**DOCUMENT NO:** OP-1903.065

**TITLE:** EMERGENCY RESPONSE FACILITY  
TECHNICAL SUPPORT CENTER (TSC)

**CHANGE NO:** PC-05

**SUBJECT:** PERMANENT CHANGE (PC)

TECHNICAL SUPPORT CENTER  
LEGEND

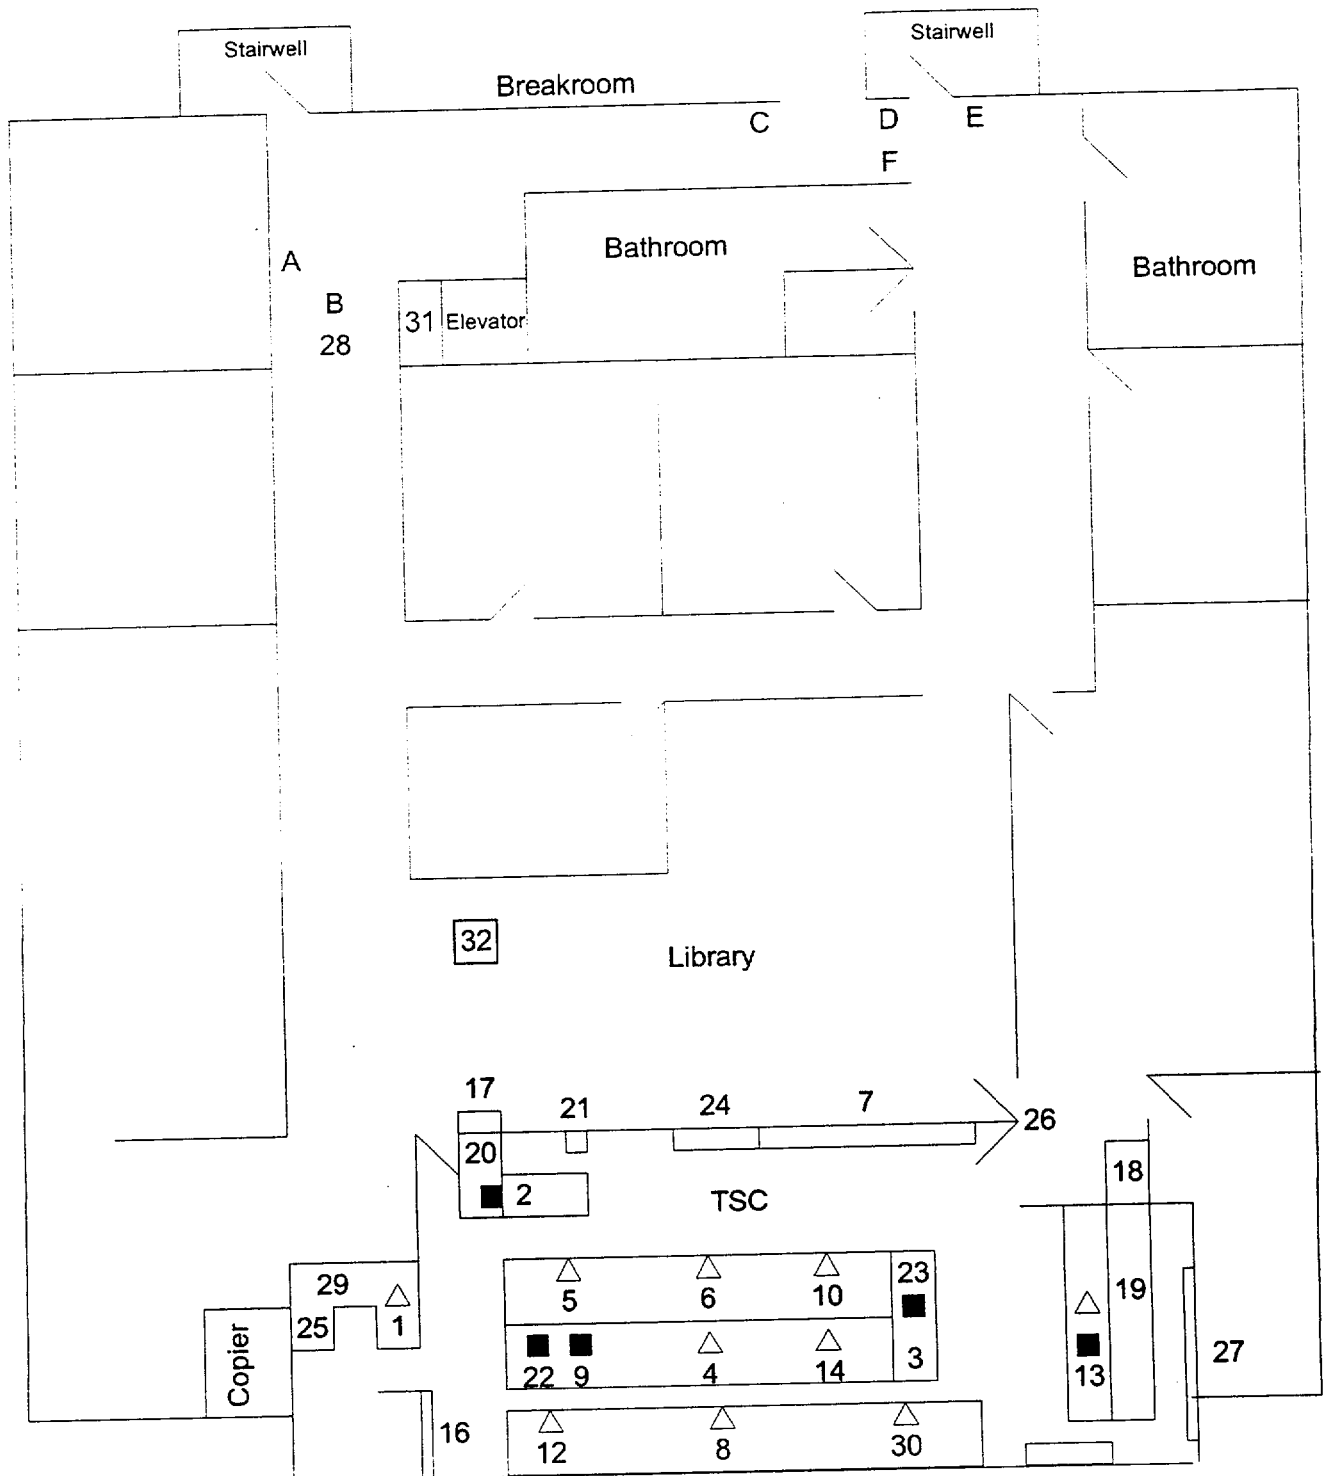
Added "3. EAL Reviewer, 7. Problems Solutions Board, 30. Operations Support" to the Technical  
Support Center Legend.  
Changed symbol for NRC telephone from a diamond (◆) to a square (■) throughout form.  
Updated drawing of TSC.
